APPROVED MINUTES

November 19, 2020 Standards Committee Meeting

RE: Minutes from the November 19, 2020 Standards Committee Meeting

E 609-RCBA-04 REINFORCED CONCRETE BRIDGE APPROACH SECTION, PAVEMENT LEDGE, AND BAR BENDING DETAILS (existing, with shown markups)

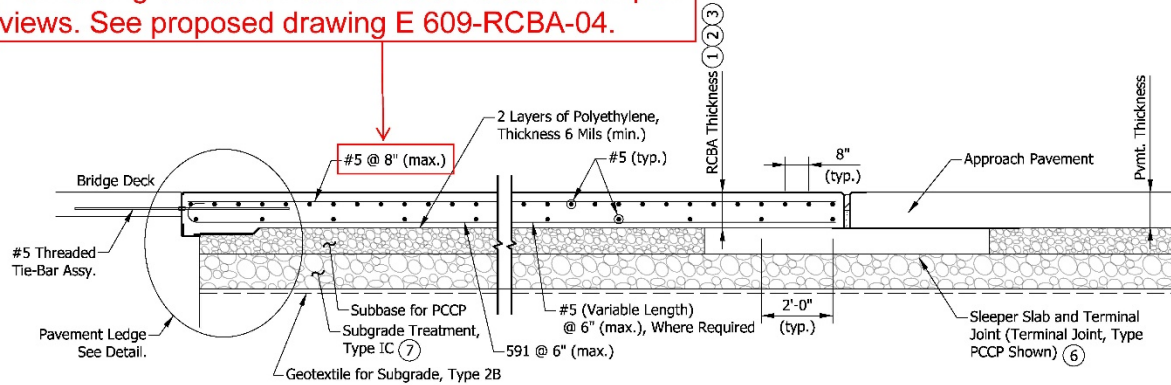
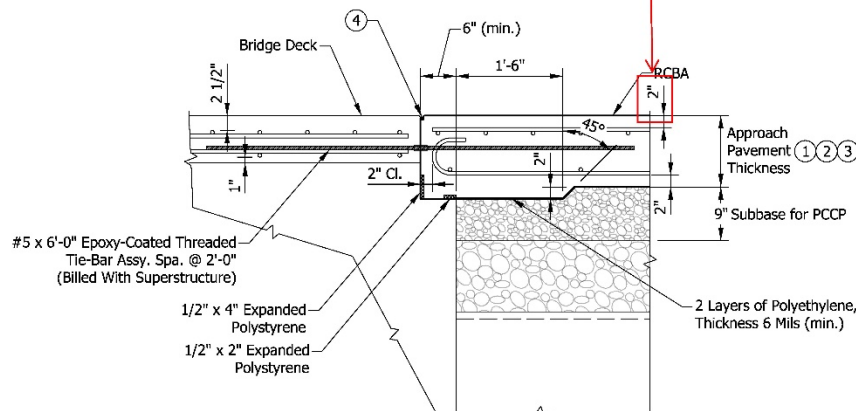
Reinforcing callout revised to be consistent with plan views. See proposed drawing E 609-RCBA-04.

Top clear cover revised to match bridge deck. See proposed drawing E 609-RCBA-04.

E 609-RCBA-04 REINFORCED CONCRETE BRIDGE APPROACH SECTION, PAVEMENT LEDGE, AND BAR BENDING DETAILS (proposed draft)

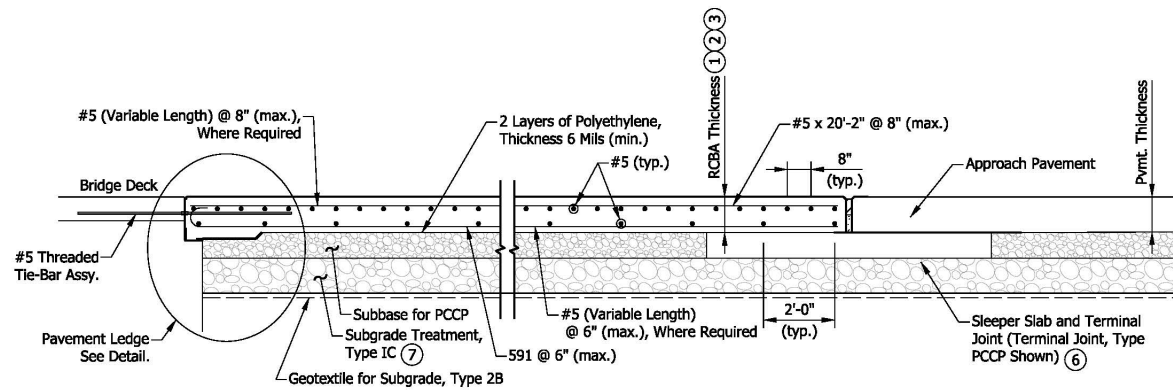
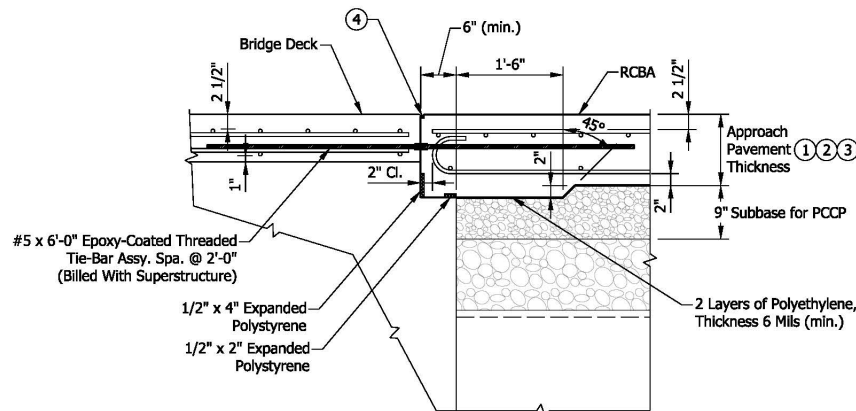
PROPOSED SOLUTION: The TBAE series has been revised to: space the transverse bars with the typical transverse bars in the RCBA, revise the orientation of reinforcing mats to be consistent with the RCBA reinforcing, remove the hooks on the longitudinal bars to reduce congestion, update the width and length of the extensions to be consistent with the current bridge railing transitions, and increase the cover on the top layer of reinforcing to 2 1/2". The RCBA series has been revised to increase the cover on the top layer of reinforcing to 2 1/2", as well as some minor editorial changes.

E 609-TBAE-01 RCBA EXTENSION FOR BRIDGE RAILING TRANSITION TFC, TPF-1, TPF-2, TPS-1, OR TPS-2 (existing, shown markups)

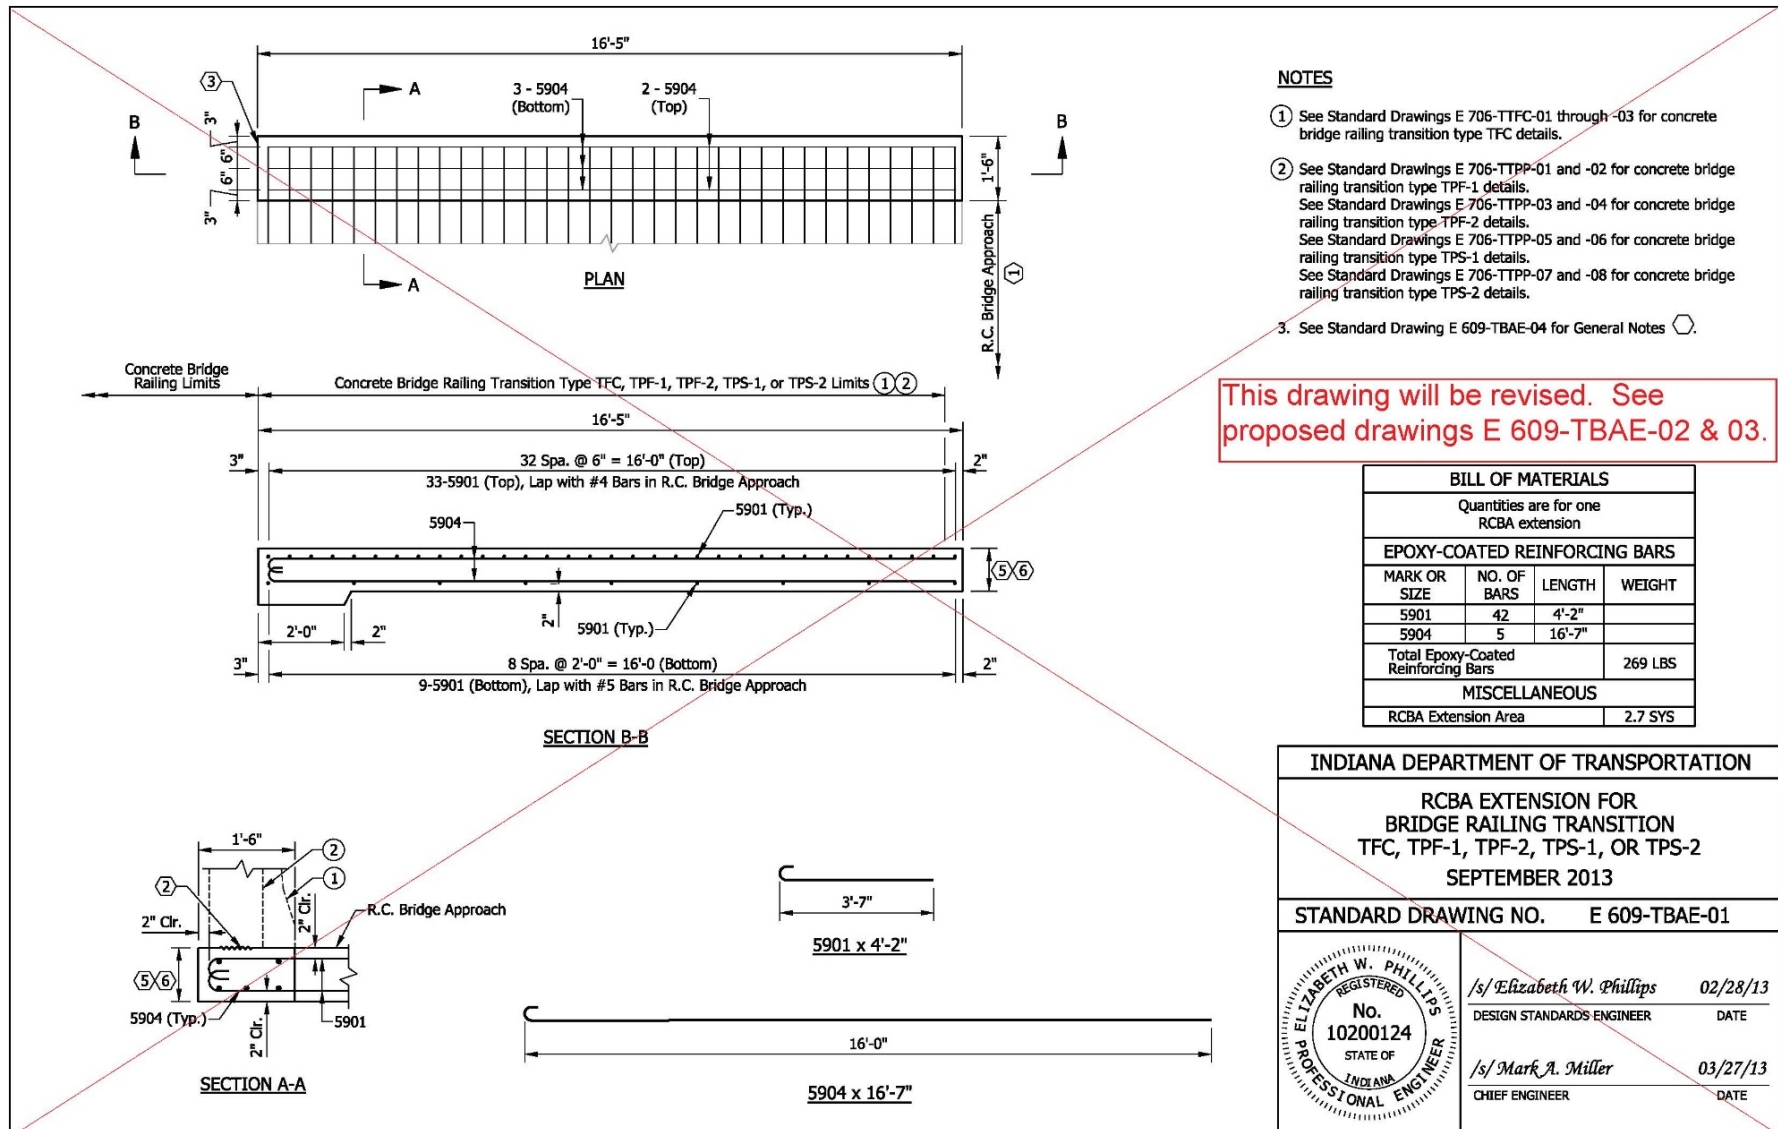
This drawing will be revised. See proposed drawing E 609-TBAE-01.

E 609-TBAE-02 RCBA EXTENSION FOR BRIDGE RAILING TRANSITION TFT, TTF-2, OR TTX (existing, shown markups)

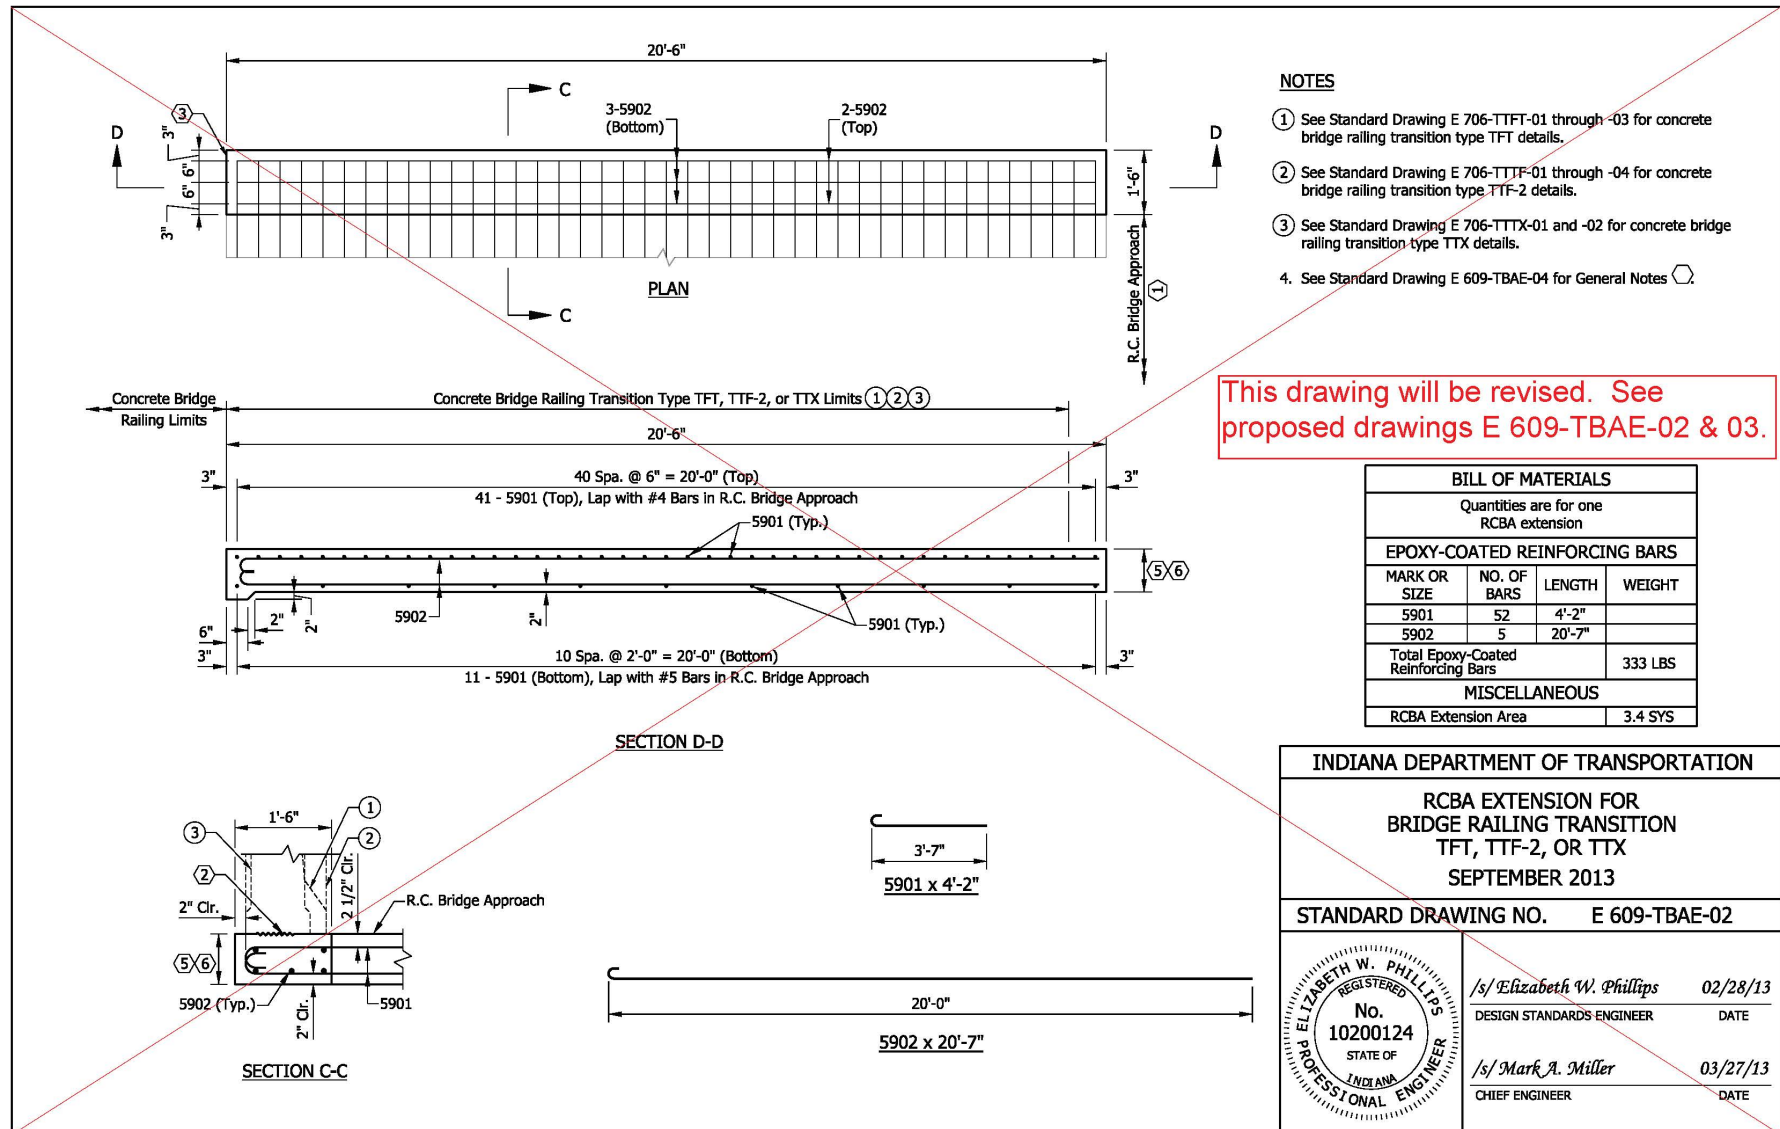
This drawing will be revised. See proposed drawings E 609-TBAE-02 & 03.
